PARTS & SERVICE NEWS

REF NO. AA01084

SUBJECT: IMPROVEMENT OF MUFFLER MOUNTING BRACKET

APPLICATION: WA120-3L Wheel Loader Serial Number A30178 and up

Figure 1

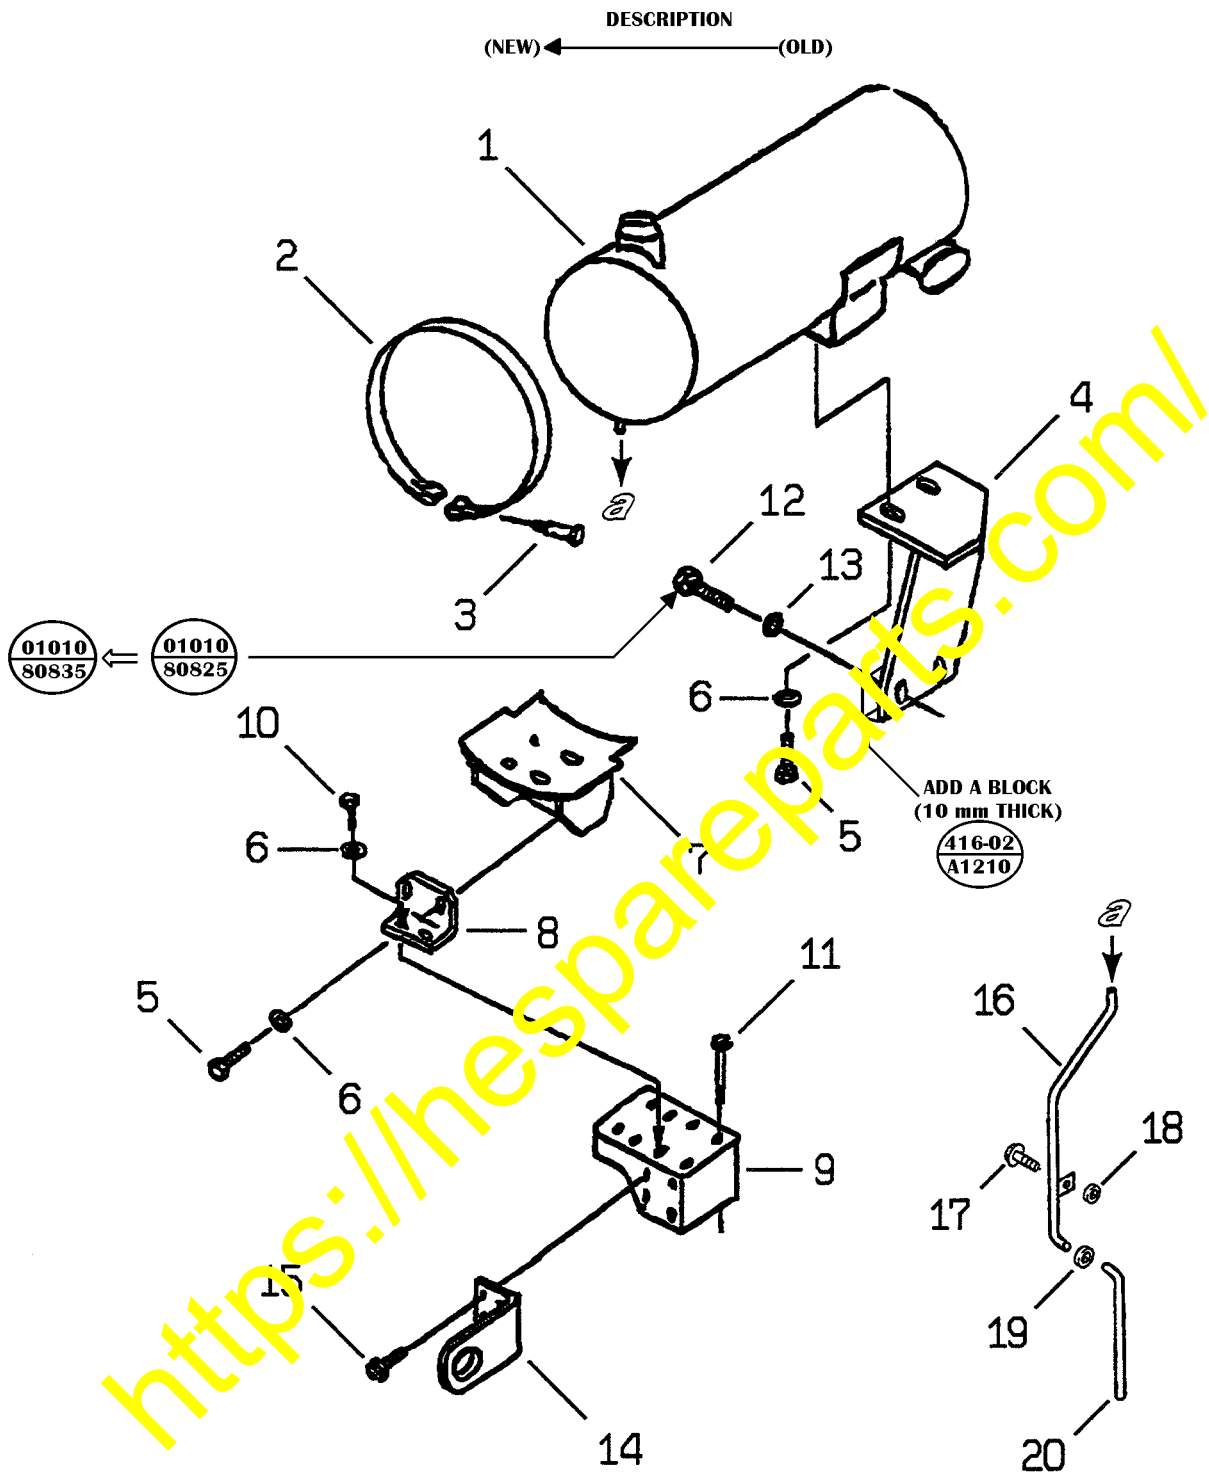
PURPOSE: To replace the existing bolt on the muffler mounting bracket and to add a block to the bracket for support.

This Parts & Service News was created to provide a stock number for a new bolt to replace the existing bolt on the muffler mounting bracket and to add a block to the bracket for support (See Figure 1). The current bolt listed in the Parts Book has a tendency to break in the field.
